**PUBLIC INTEREST REVIEW FOR GROUNDWATER APPLICATIONS**

TO: Water Rights Section Date 08/21/2015  
 FROM: Groundwater Section Jen Woody  
 Reviewer's Name  
 SUBJECT: Application G- 18100 Supersedes review of n/a Date of Review(s)

**A. GENERAL INFORMATION:** Applicant's Name: Peggy Hwang RLT County: Marion

Figure 1. Well Location Map

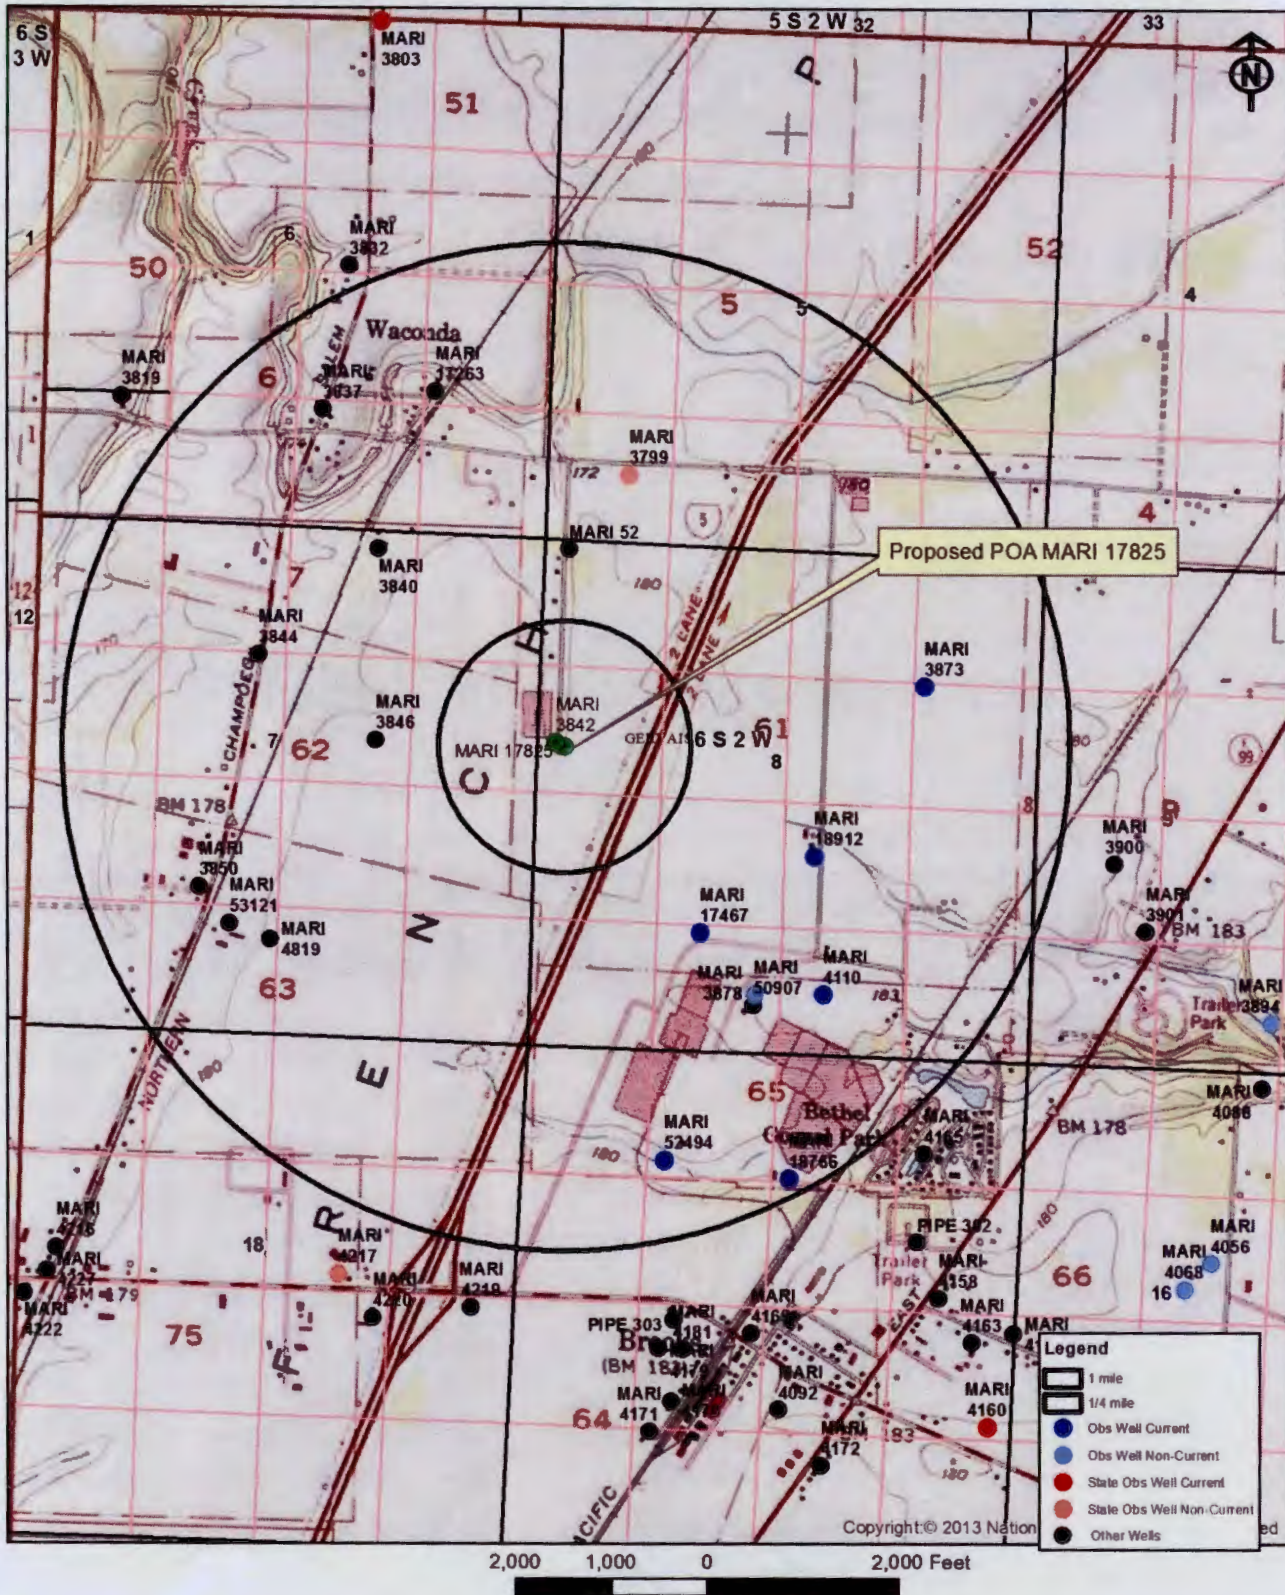
As shown in Figure 1, the proposed POA is located about 100 feet southeast of MARI 3842, the POA associated with Certificate 47850. MARI 3842 and MARI 17825 are about the same depth, and have about the same open interval. The potential for well-to-well interference is significant, especially during the late summer when water levels are at their annual low. The cone of depression created by pumping is expected to rapidly propagate toward aquifer boundaries in a confined aquifer, and it will be shallow and broad. Condition 7C is recommended to address the potential hydraulic interference.

- i.  The permit should contain condition #(s) 7C;
  - ii.  The permit should be conditioned as indicated in item 2 below.
  - iii.  The permit should contain special condition(s) as indicated in item 3 below;

Figure 2. Stream Depletion calculations indicate the hydraulic connection between the proposed POA and Patterson Creek is very inefficient.

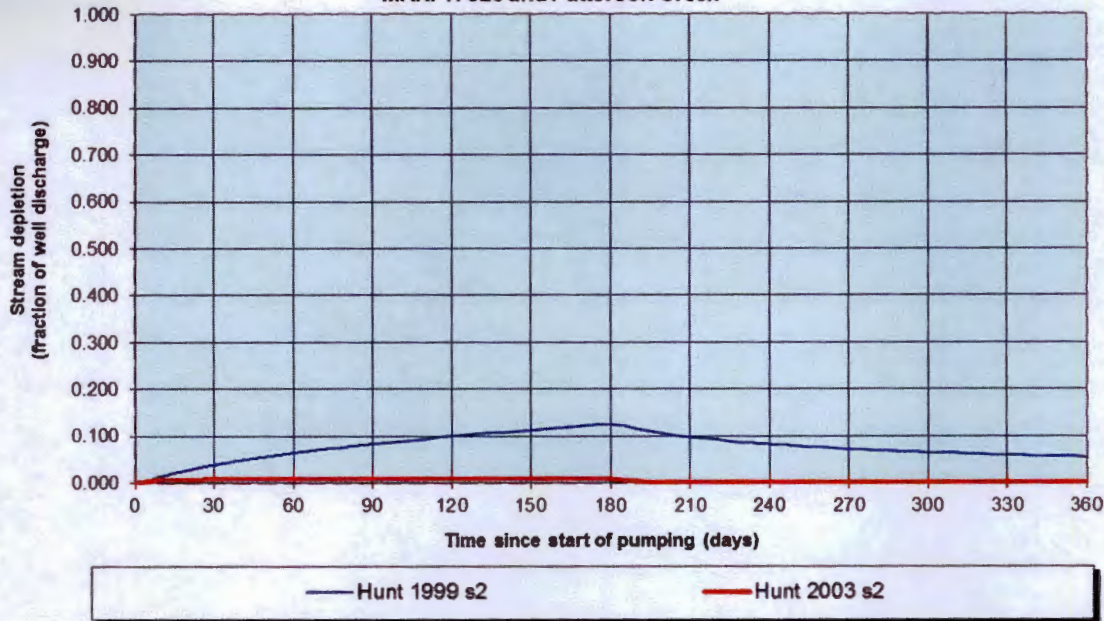
**Comments:** Stream depletion estimates using Hunt (2003) indicate interference at 30 days will be much less than 25% of the well discharge. See Figure 2.

Figure 3. Winter water levels in nearby wells show the Willamette Aquifer is generally stable or slightly declining under the current pumping and climatic conditions.

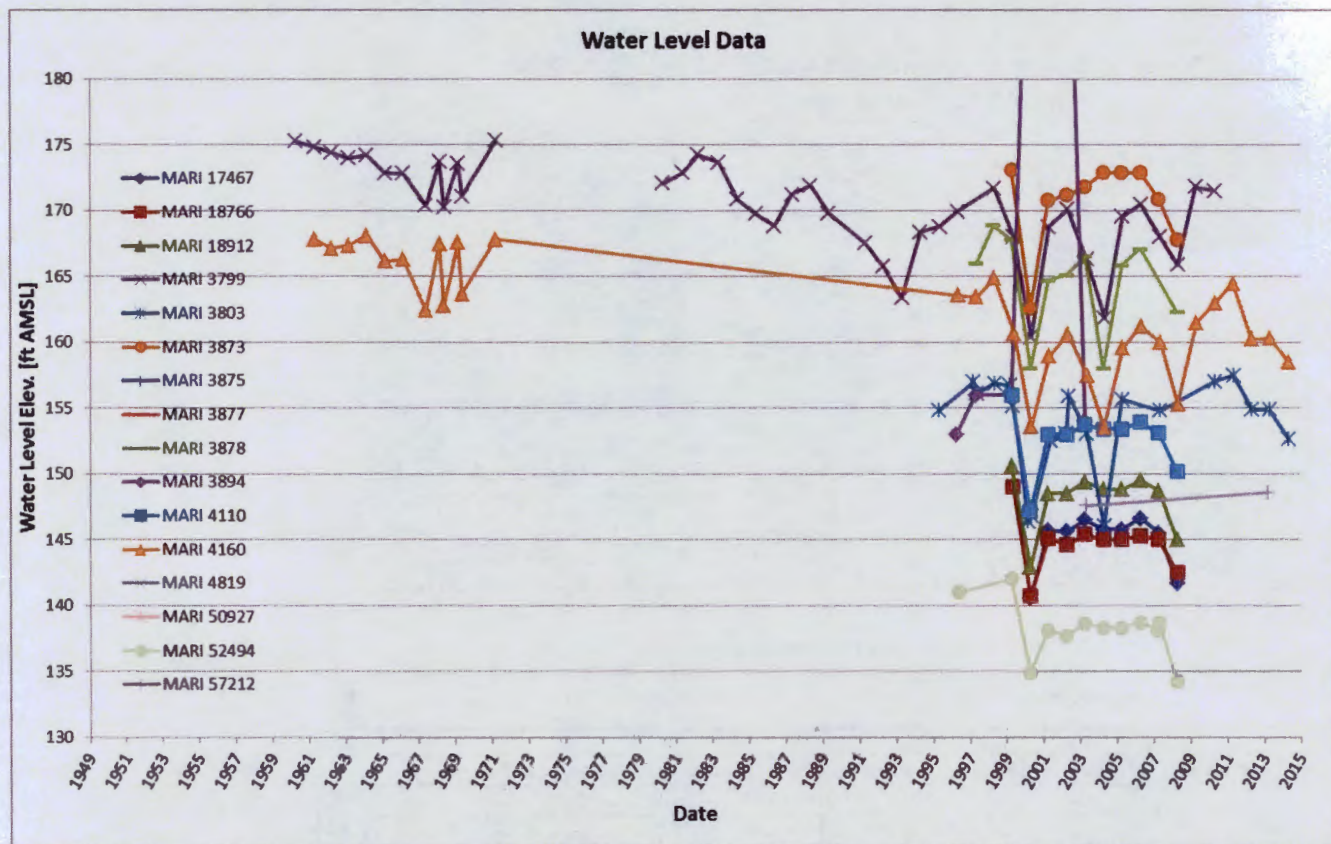
Water levels from some nearby wells in the Willamette aquifer show minor groundwater declines. It is unclear whether these trends should be attributed to increased pumping or decadal scale climatic fluctuations. There is not enough data to determine over-appropriation of the groundwater system, especially when many wells show long-term stability (see Figure 3). Overall, the water level data indicate the system can support further development, but water level monitoring is recommended to monitor the impacts.
